**Doc 9710, VAP/13**

INTERNATIONAL CIVIL  
AVIATION ORGANIZATION

## **VISUAL AIDS PANEL**

## **REPORT**

Figure 5.7 High-/medium-intensity dual obstacle lighting system, Type A/Type B

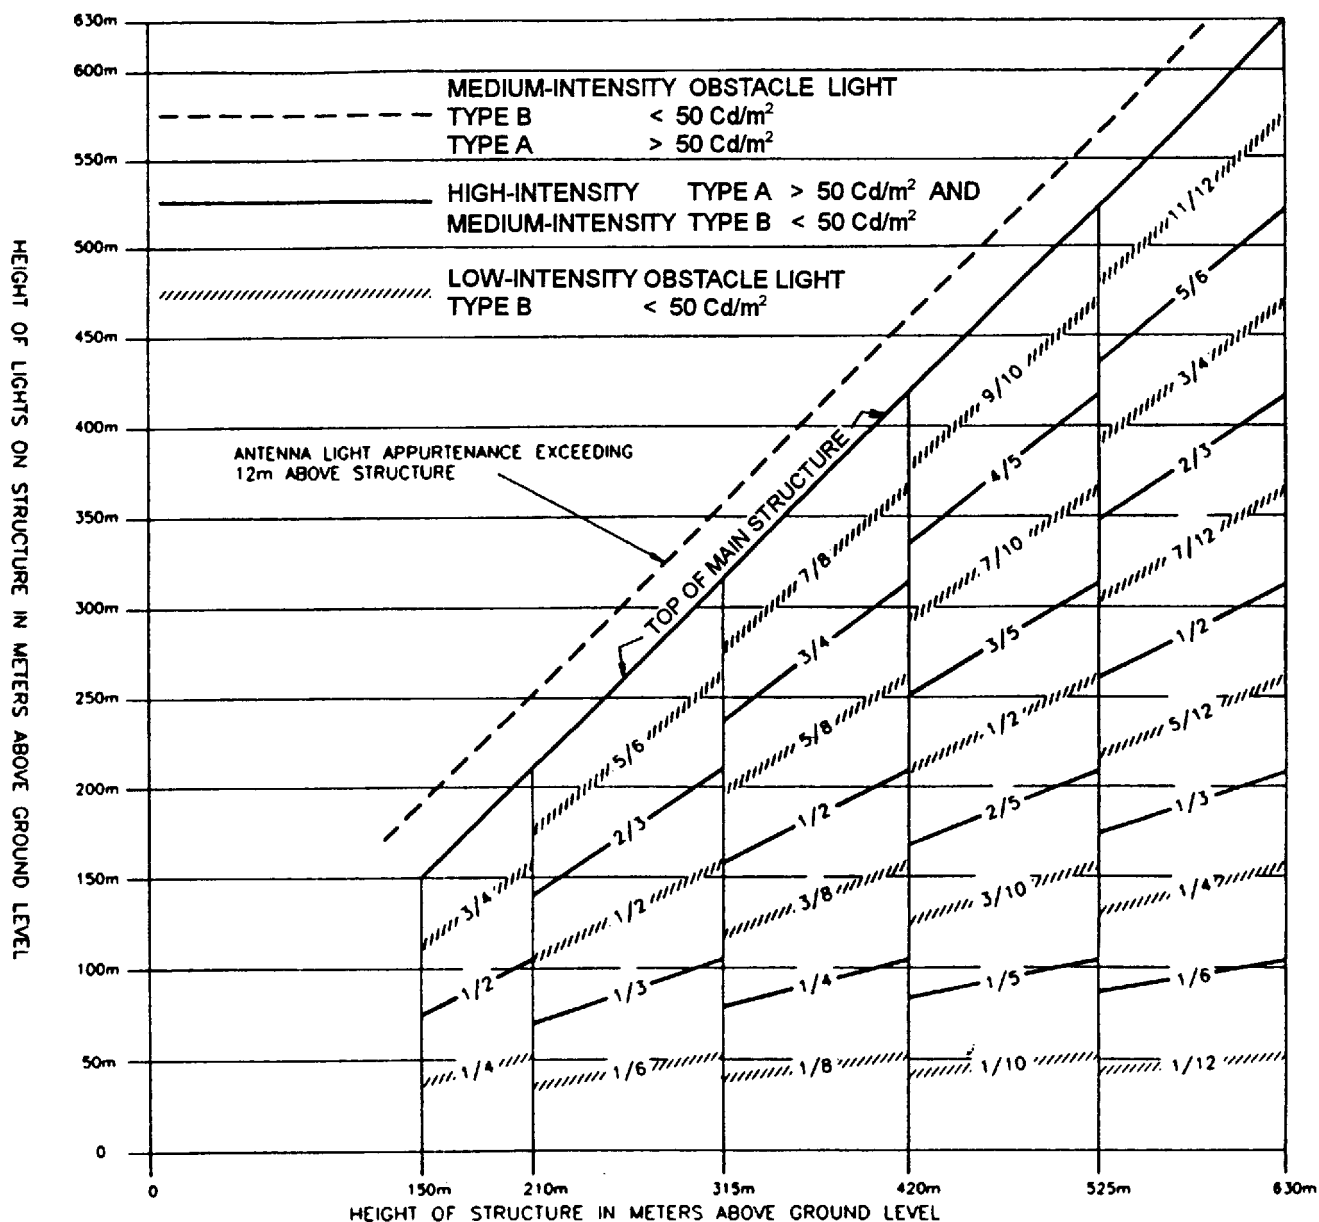
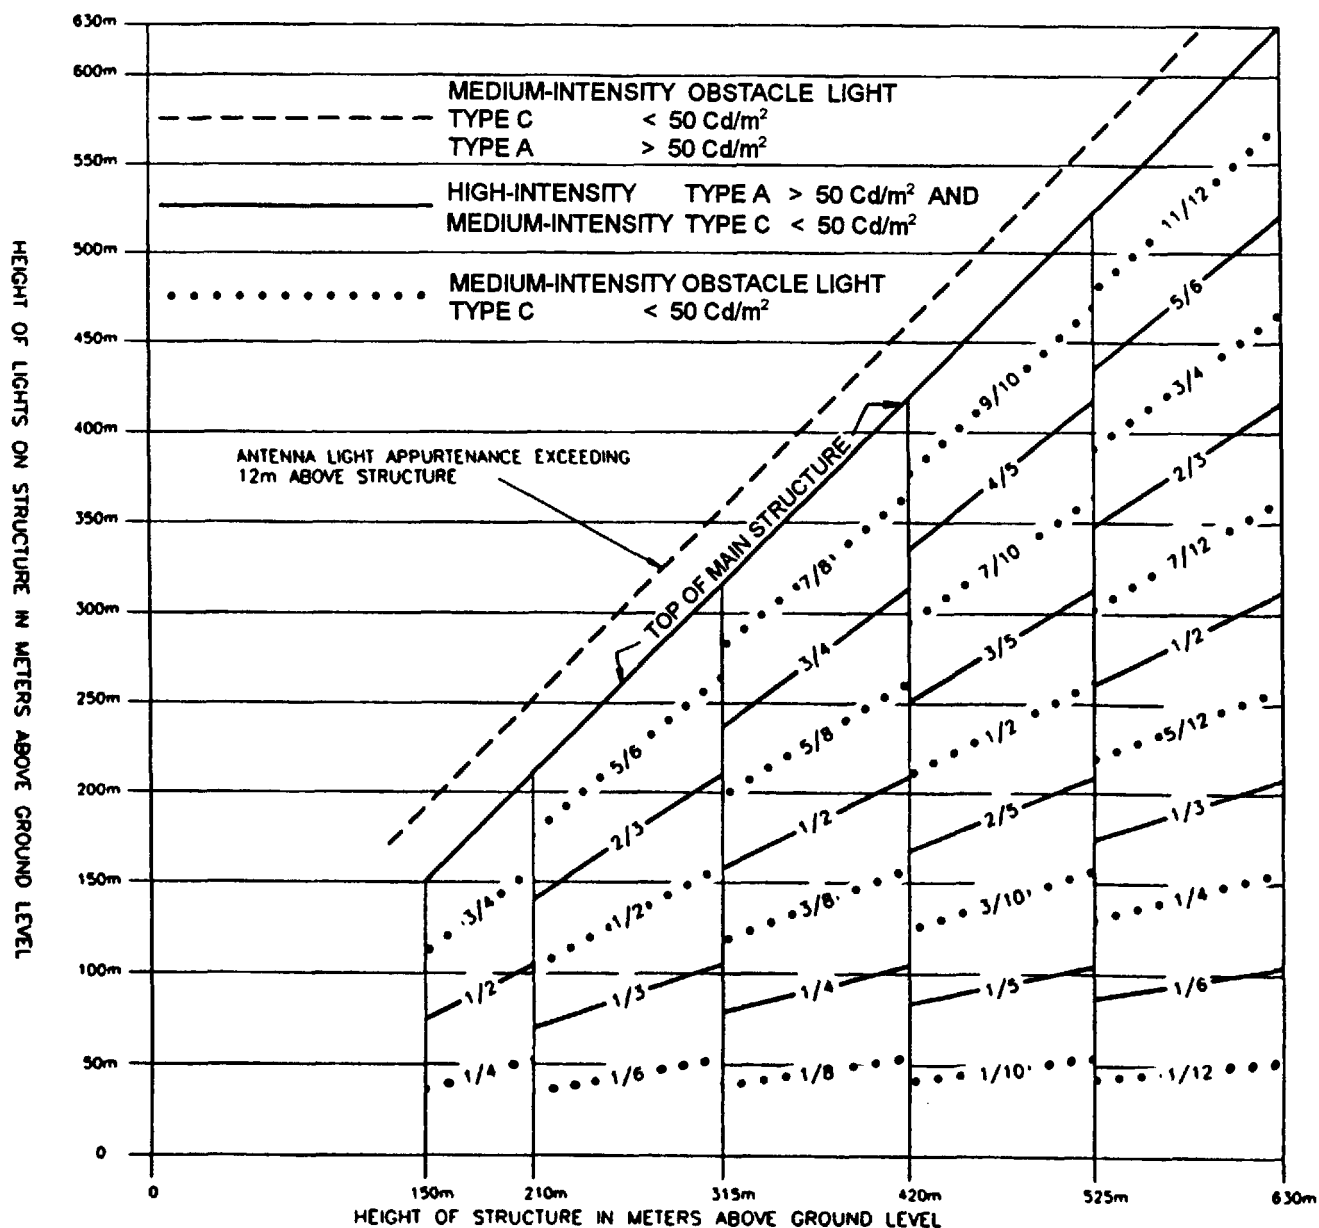
Insert new Appendix 6 as follows:

Note.- High-intensity obstacle lighting is recommended on structures more than 150 m AGL. If medium-intensity lighting is used, marking will also be required.

Figure 4-2. Reduced lighting pattern as proposed by the working group

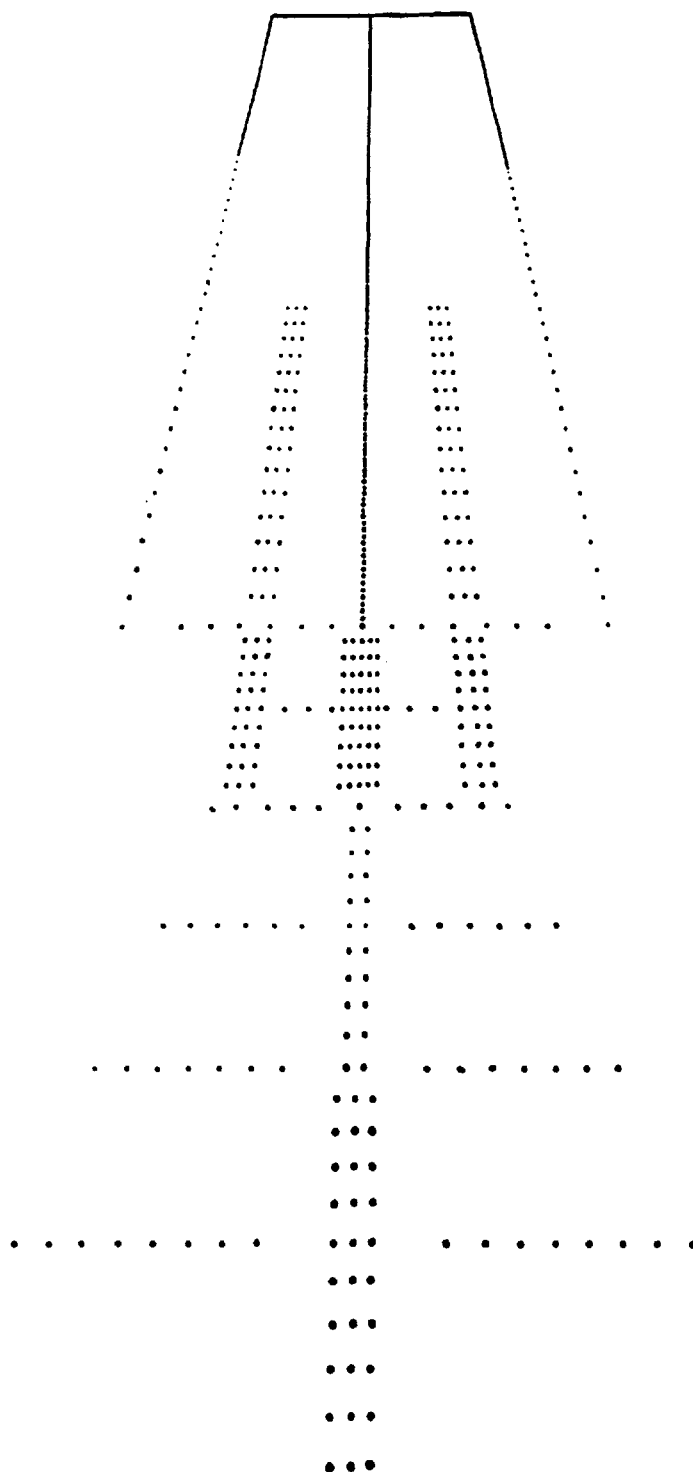
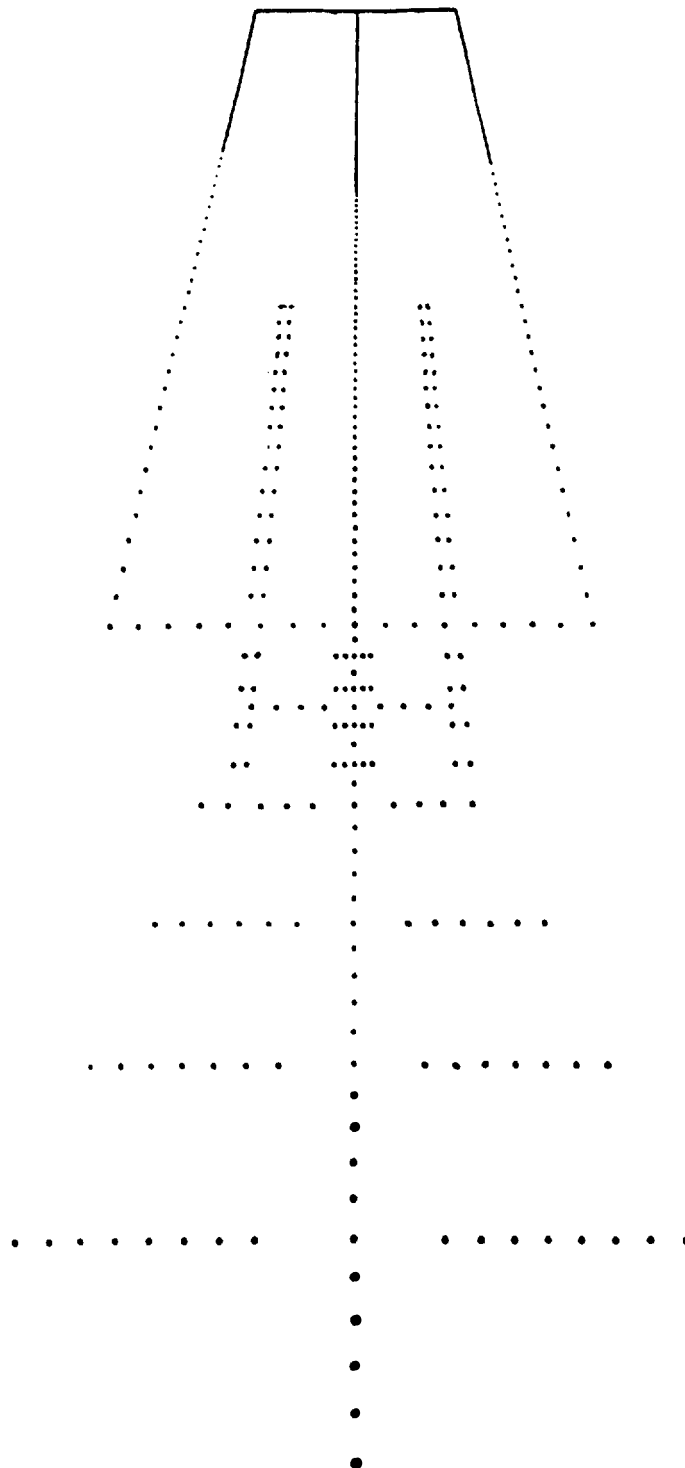
4.2.1.5 The lighting currently specified in Annex 14, Volume I for precision approach runways categories II and III is illustrated in Figure 4-1 below. The reduced lighting pattern developed by the working group on the basis of the United Kingdom trials is illustrated in Figure 4-2 below.

Figure 5-8. Inner 300 m approach and runway lighting for precision approach runways categories II and III

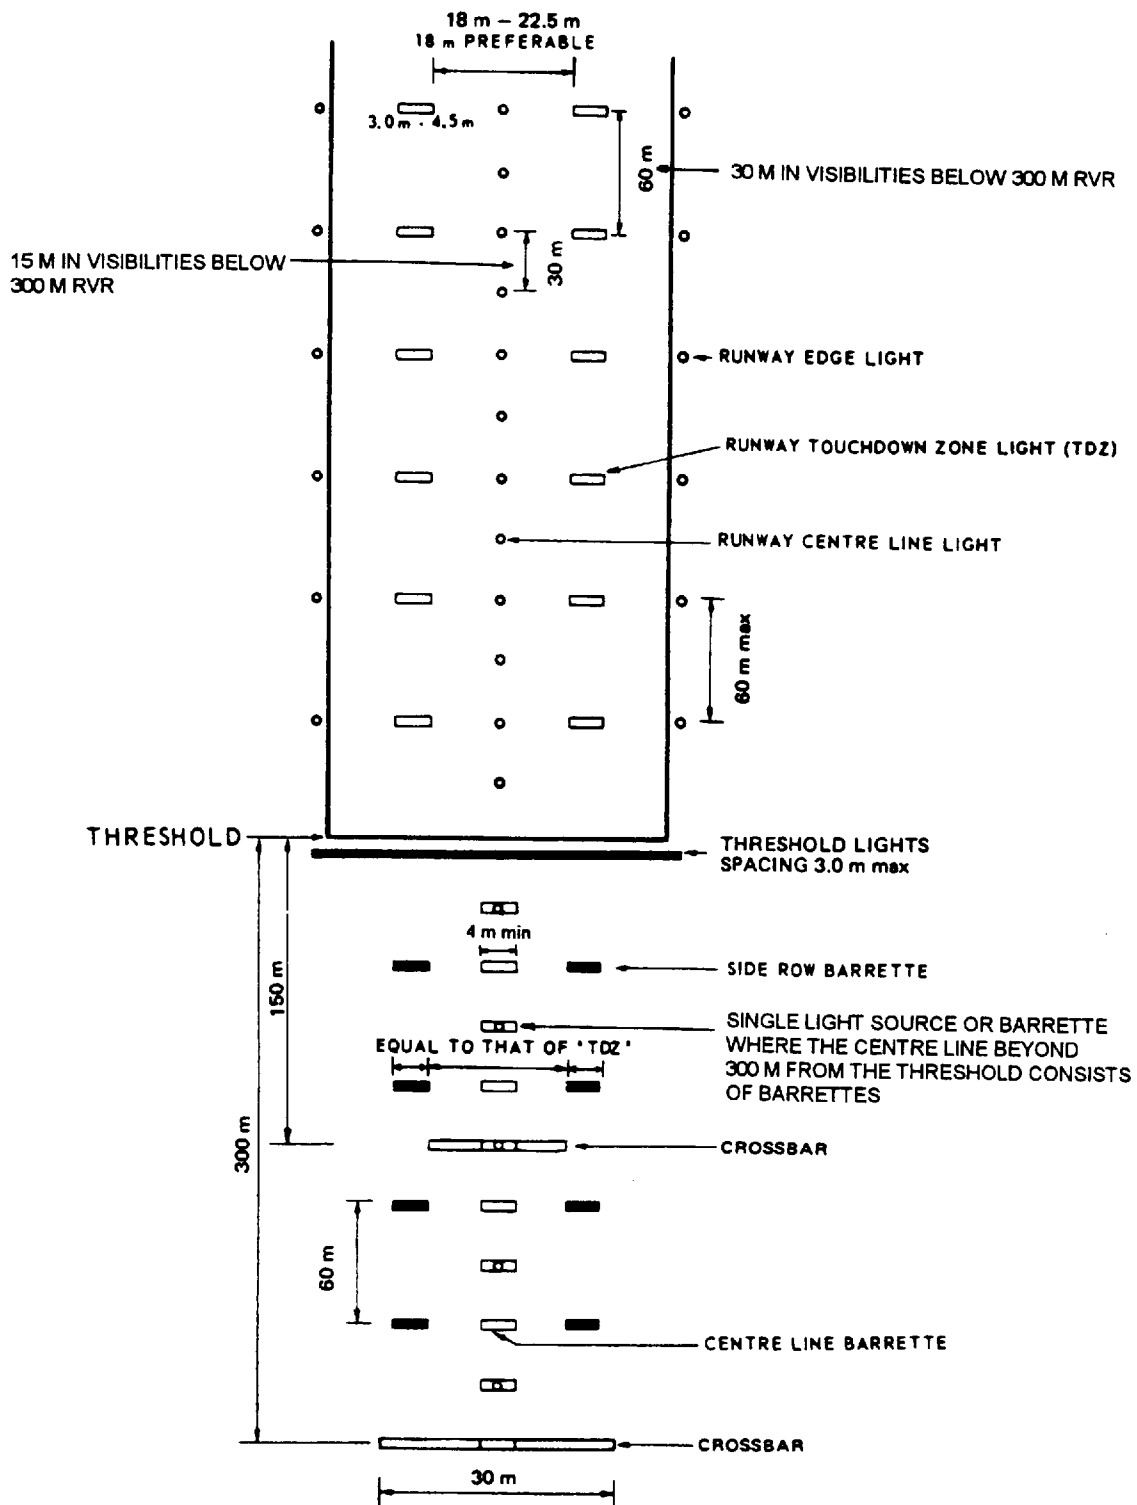
*Editorial Note.*— *Revise Figure 5-8 as follows:*

5.3.4.20 The approach lighting system shall consist of a row of lights on the extended centre line of the runway, extending, wherever possible, over a distance of 900 m from the runway threshold. In addition, the system shall have two side rows of lights, extending ~~270 m~~ 240 m from the threshold, and two crossbars, one at 150 m and one at 300 m from the threshold, all as shown in Figure 5-8.
